Work Order ID 132167

Item Name: Aft Crosstube - High 407

Reference: REWORK PER ECN 15-557

DRAWN	RF		
CHECKED	RF		
MFG. APPR.	RF		
APPROVED	RF		
DE APPR.	RF		
DATE	15.03.20		
DART AEROSPACE LTD HAWKESBURY, ONTARIO, CANADA DRAWING NO. D407-667-245 TITLE CROSSTUBE ASS'Y (407 HIGH AFT) SCALE NTS COPYRIGHT © 2002 BY DART AEROSPACE LTD THIS DOCUMENT IS PRIVATE AND CONFIDENTIAL AND IS SUPPLIED ON THE EXPRESS CONDITION THAT IT IS NOT TO BE USED FOR ANY PURPOSE OR COPIED OR COMMUNICATED TO ANY OTHER PERSON WITHOUT WRITTEN PERMISSION FROM DART AEROSPACE LTD.

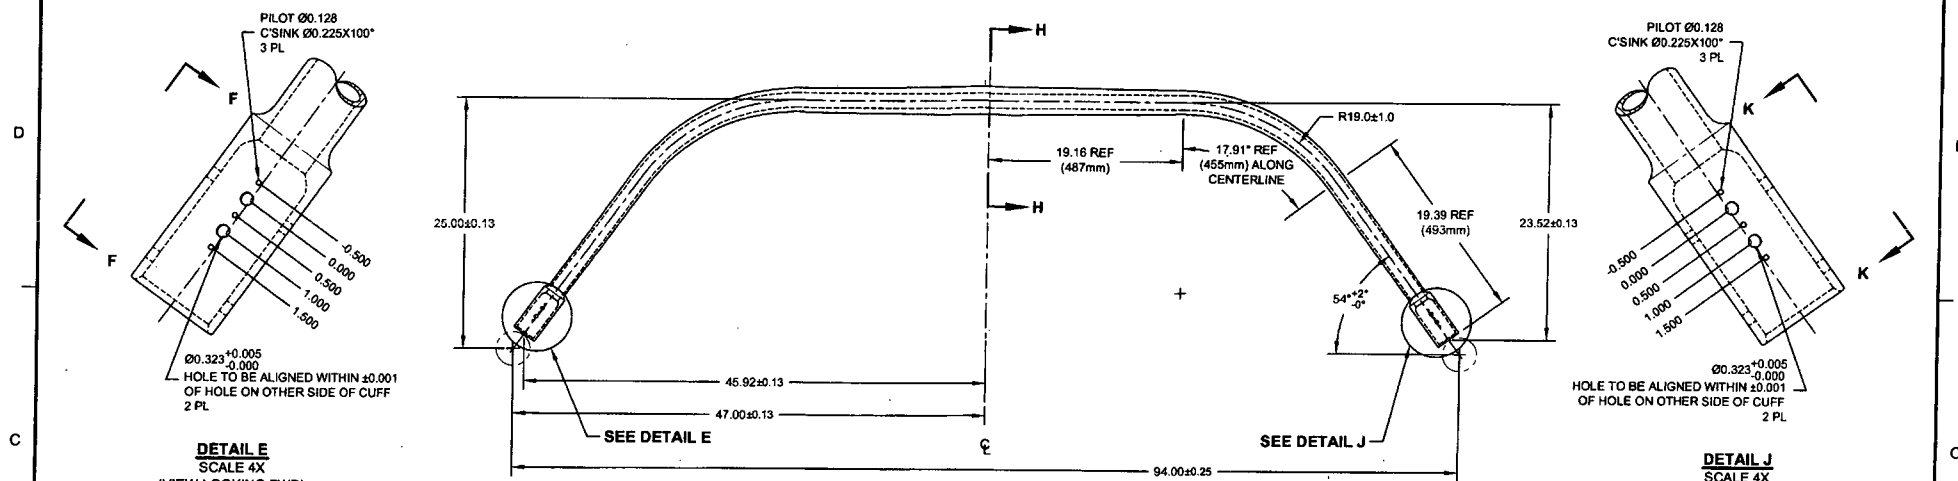
G	INCORP. DEO's D407-667-245-F1/F2 (ZN D8-1, A8-1, D5-2, B6-2, C6-2); 8.90 WAS 8.53 (ZN D5-2); TORQUE REDUCED FOR CHAFING SHIELD (ZN A8-1); FINISH REVISED TO ALLOW MANUFAC. FLEXIBILITY (ZN C8-1)	RF	15.03.20
F	REFORMAT NOTES TO NEW STANDARDS (ZN B8-1); RELOCATED FLAG # 6 (ZN A8-3) PER NCR 210; REMOVED REF. & ADD TOLERANCES (ZN C6-3, C4-3 & D2-3)	RF	08.11.06
E	8.02 AND 8.53 WERE 8.40 AND 8.90 (ZN D5-2); REORGANIZED VIEWS AND REFORMATED DRAWING TO CURRENT STANDARDS. REASONS: CLAMPS MOVED 0.375 TOWARD CL TO ELIMINATE INTERFERENCE WITH AIRCRAFT MOUNTS. REFERENCE: PAR#08-21 AND ECN#1225	MB	08.07.24
D	ADD VIEW FOR OEM SKID HOLES, ROTATE ORIENTATION OF CLAMPS SECTION F-F, REMOVE -851 ABRASION STRIP, ADD MAGNOBOND 6398, ADD CUSHION	PH	07.02.07
C	ADD HOLES AND NUT PLATES FOR COMPATIBILITY WITH BHT/AA SKIDTUBES	PH	05.07.26
B	ADD CHAFING SHIELD	CP	03.05.21
A	NEW ISSUE	CP	02.05.13
REV.	DESCRIPTION	BY	DATE
DESIGN	RF

D407-667-605
BENDING AND DRILLING DETAIL
(VIEW LOOKING FWD)

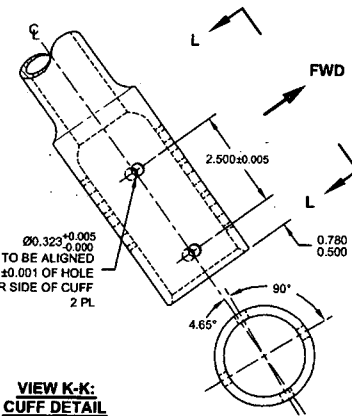
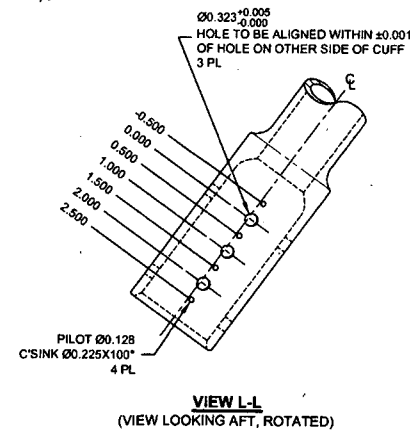
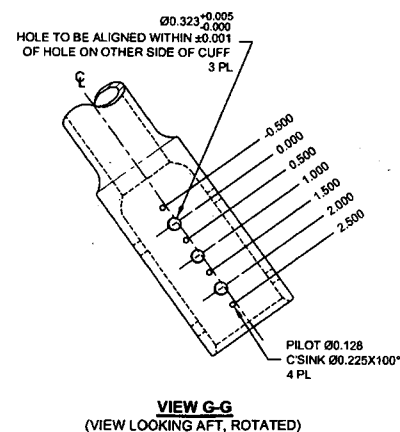
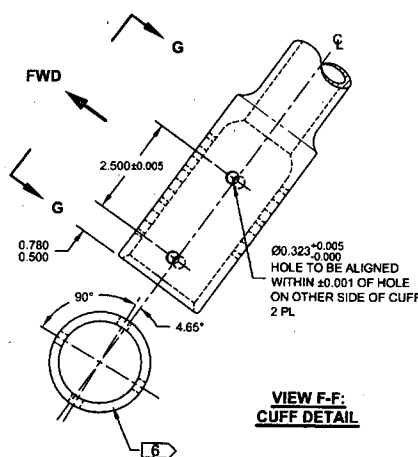
1- Install chafing shield as per D407-667-245 using DT10096 to establish 8.90
dimention.Top holes should be facing up.

****Ensure chaffing is to be position "overlap" AFT****
